City of Detroit
Inter-Departmental Communication

RE: Petition No. 610
Requested Dedication Of Public Street Dickerson Ave. From East Jefferson Ave.
To Freud Ave.

NOTICE OF PROPOSED CHANGE IN PROPERTY

REQUEST DEDICATION OF PUBLIC STREET
 DICKERSON AVE. FROM E. JEFFERSON AVE.
 TO FREUD AVE.

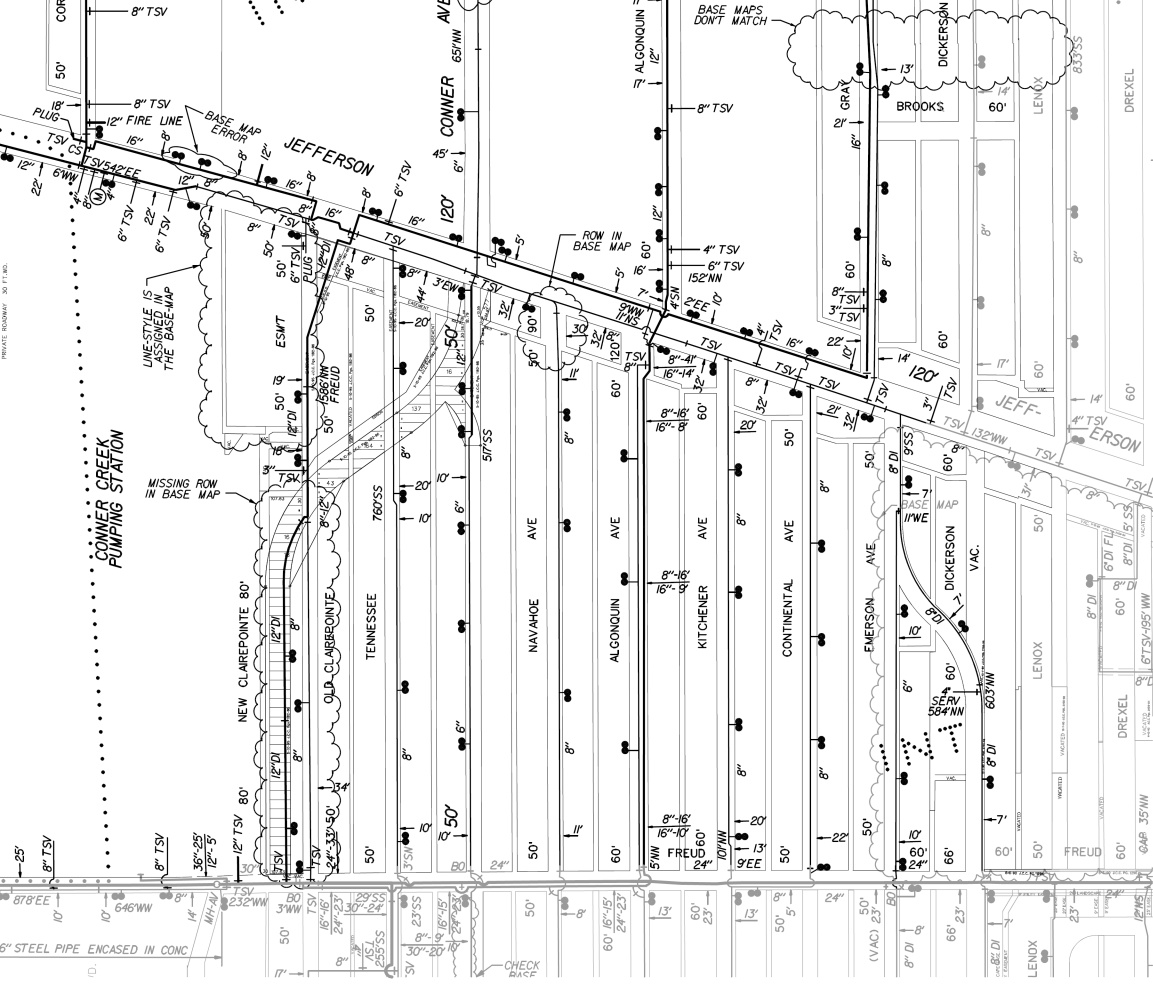
- DWSD has no objections to the requested Dedication
